WPX Energy Plug & Abandon Procedure December 20, 2016

Rosa #350

Attachment to notice of Intention to Abandon:

CONDITIONS OF APPROVAL

ROSA UNIT #350 BASIN FRUITLAND COAL Proposed P&A

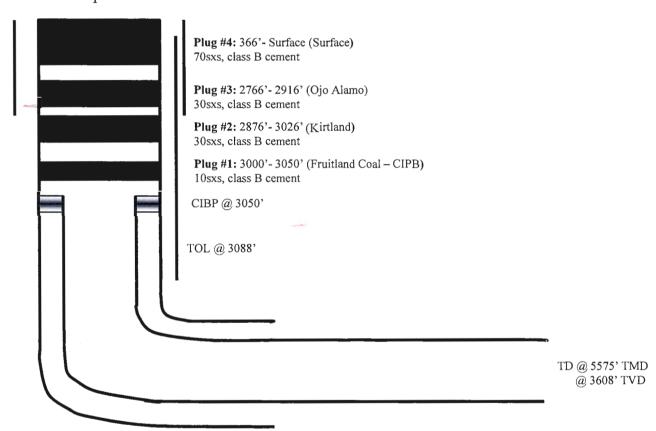
- 1. Plugging operations authorized are subject to the attached "General Requirements for Permanent Abandonment of Wells on Federal and Indian Lease."
- 2. Farmington Office is to be notified at least 24 hours before the plugging operations commence (505) 564-7750.
 - a) Combined Plug #2 and #3 (3026'-2766') ft. to cover the Ojo Alamo top. BLM picks top of Kirtland at 3061'ft and Ojo Alamo at 2942.
 - b) Add plug to cover Nacimiento top set plug (1560'-1660') ft. to cover Nacimiento top. BLM picks top of Nacimiento at 1610' ft.
